# CITY PLANNING COMMISSION

APPLICANT	Allan S. Irwin, 5770 Carlson Drive, Sacramento, CA 95819		
OWNER	Fremont Presbyterian Church, 5770 Carlson Drive, Sacramento, CA 95819		
PLANS BY	Pacific Neon Company		
FILING DATE	4-23-86	ENVIR. DET.	Ex 15311(a) REPORT BY CV:tc
ASSESSOR'S-PCL. NO.	005-221-07

- APPLICATION:**
- A. Variance to increase allowable square footage for a monument sign from 16 square feet to 48 square feet.
  - B. Variance to locate a monument sign in the front setback. (Withdrawn by staff)
  - C. Variance to allow a seven foot high sign.

**PROPOSAL:** The applicant is requesting the necessary entitlements to construct a 48 sq. ft. monument sign consisting of a reader board.

APPROVED: [Redacted]  
 LOCATION: [Redacted] SACRAMENTO, STATE OF CALIFORNIA  
 SALESMAN: [Redacted]  
**EXHIBIT A**

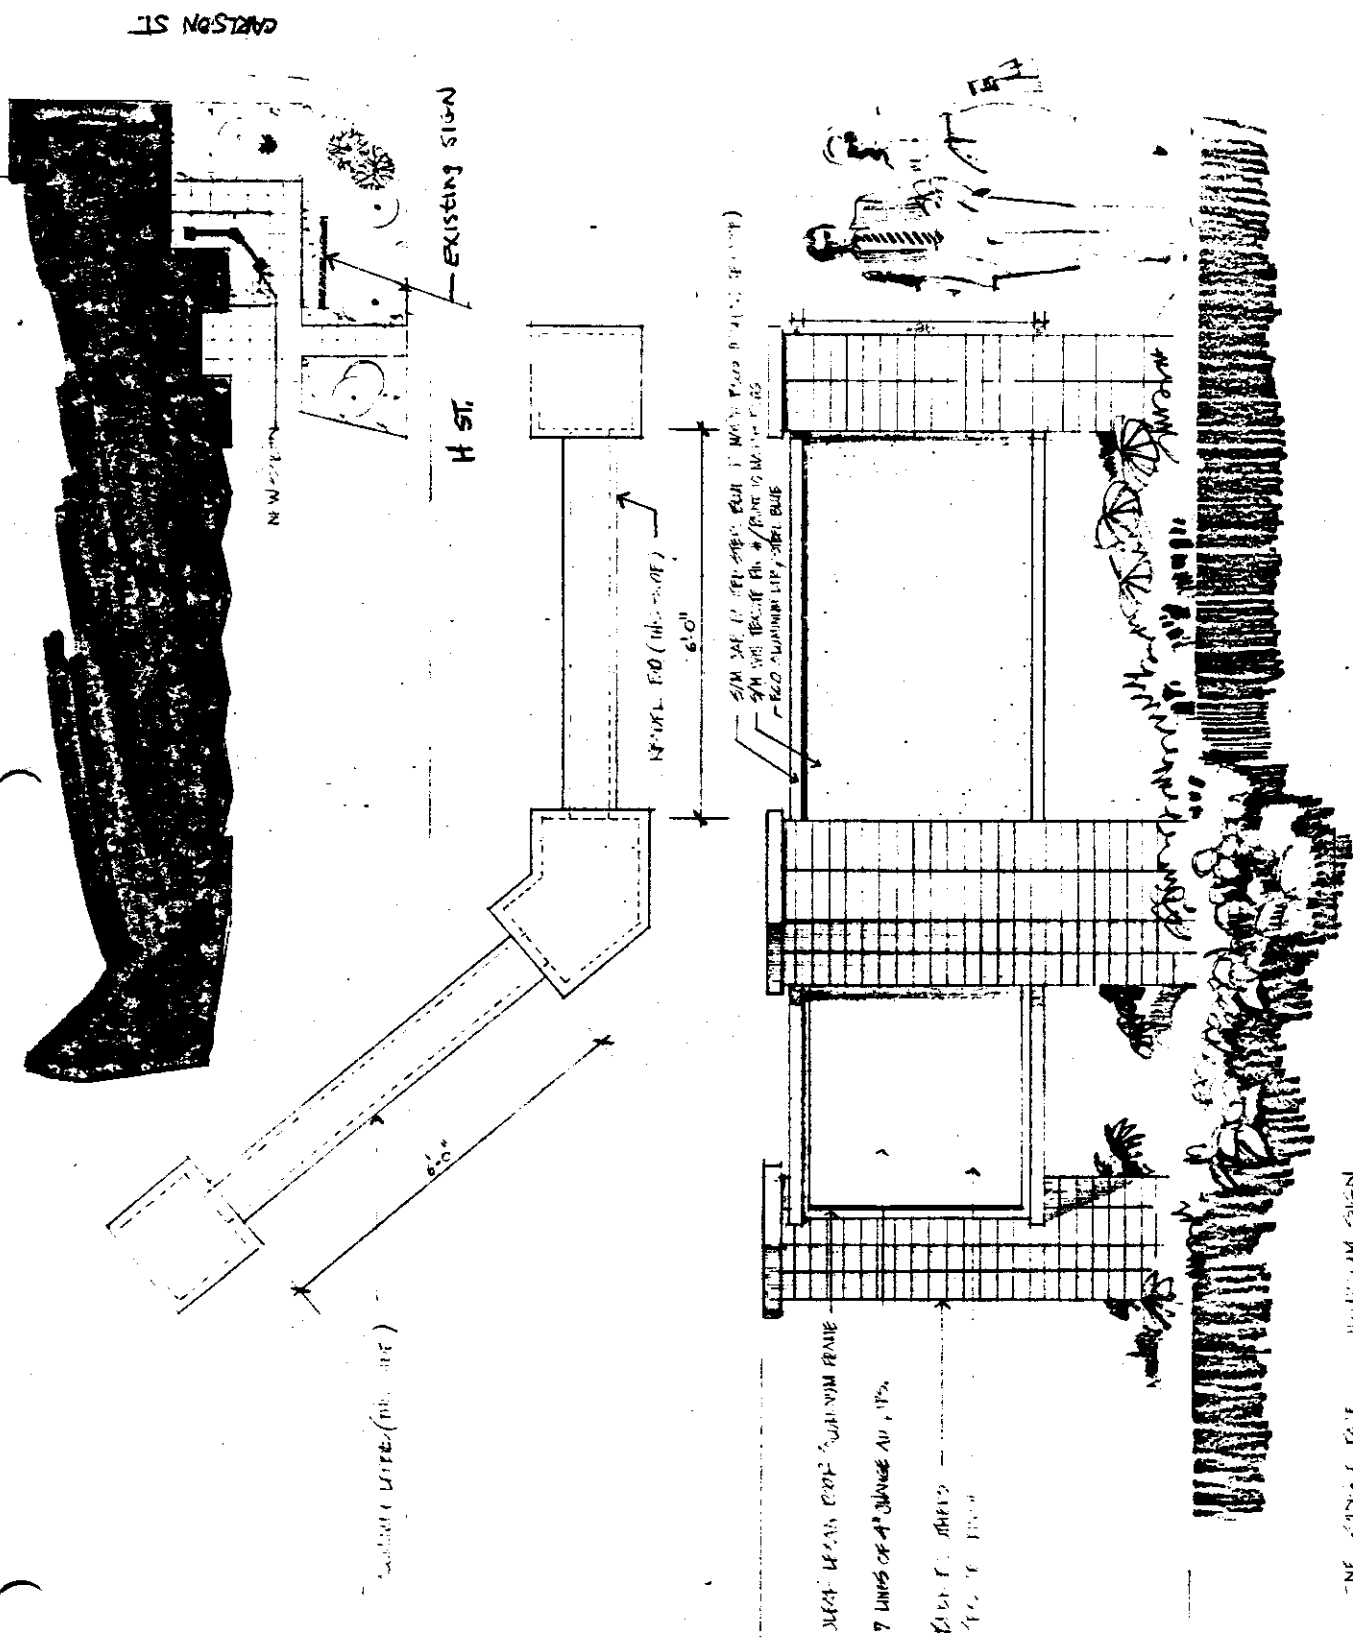
The height of the monument sign proposed is seven feet. Staff finds no reason to support a seven foot high monument sign and recommends the height be limited to six feet as required by the Sign Ordinance. A reduction in height of one foot will not adversely affect the design or the visibility of the sign from Carlson Drive or H Street.

- A. Approval of the variance to increase the allowable square footage from 16 sq. ft. to 24 sq. ft., subject to conditions and findings of fact which follow:
- B. Denial of the variance to allow a seven foot high sign.

## EXHIBIT B

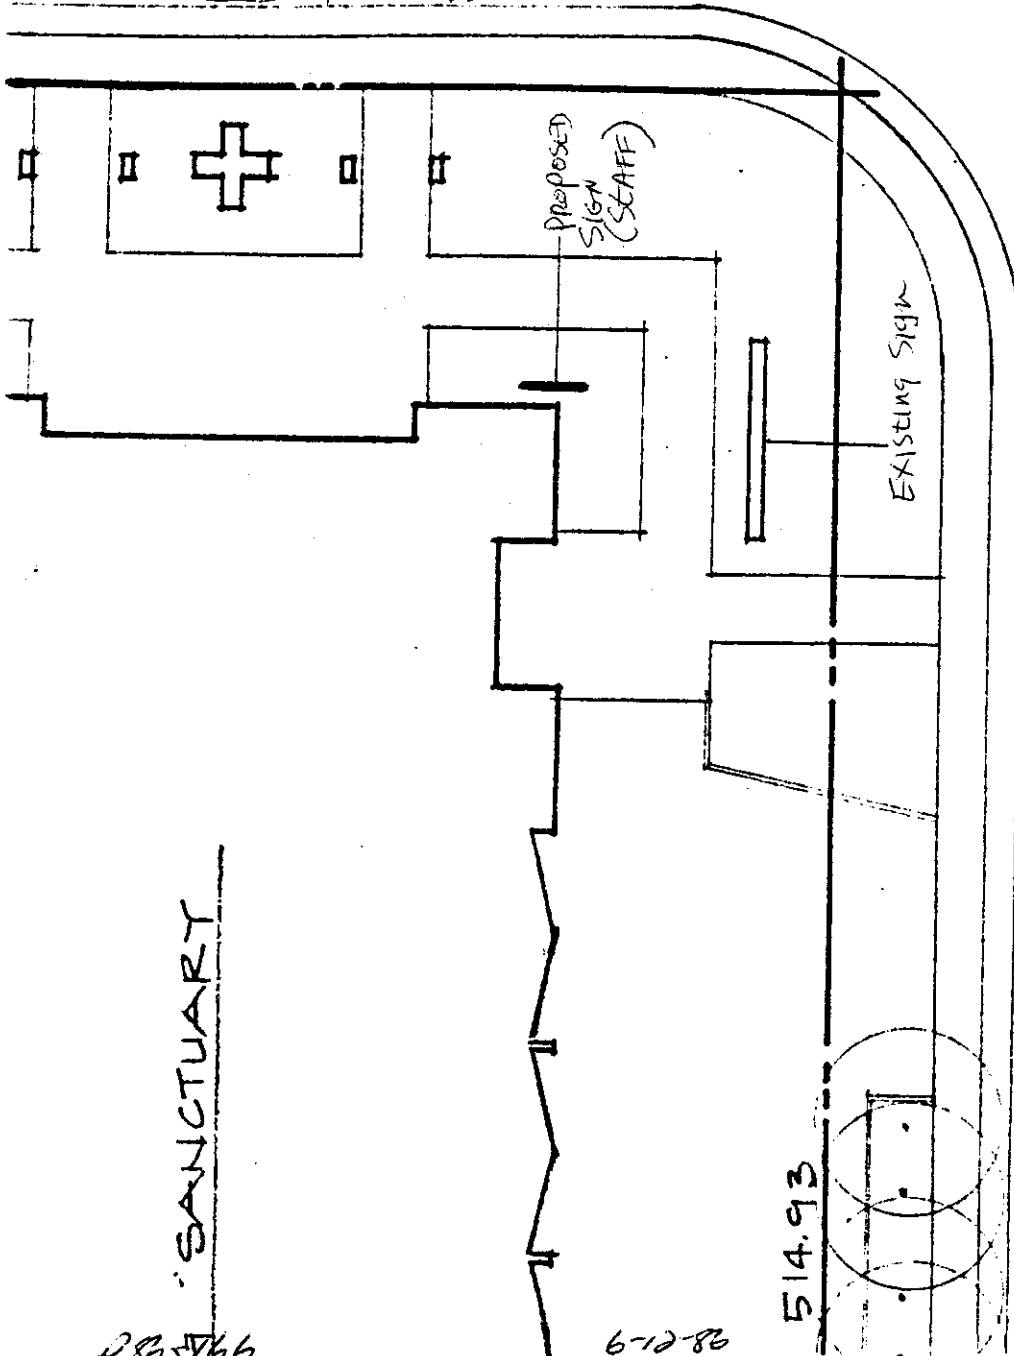
Staff recommends the proposed 48 square foot sign be redesigned to reduce the square footage to 24 square feet and placed so that the proposed sign faces Carlson Drive (see Exhibit B). Since there is already one church identification monument sign located on site facing H Street, staff cannot support a 48 square foot monument sign to be used only as a message board. Also, a portion of the proposed monument sign located directly behind the existing monument sign would not be clearly visible to motorists on H Street.

1. The three plywood signs presently located in front of the church shall be removed prior to issuance of a sign permit.
3. The monument sign shall be located behind the 31 foot front setback as indicated on the site plan (exhibit B).
4. The monument sign shall be constructed of brick and the sign face shall be constructed per the plans submitted by the applicant.
5. Revised plans shall be submitted for review and approval of the Planning Director prior to issuance of a sign permit.
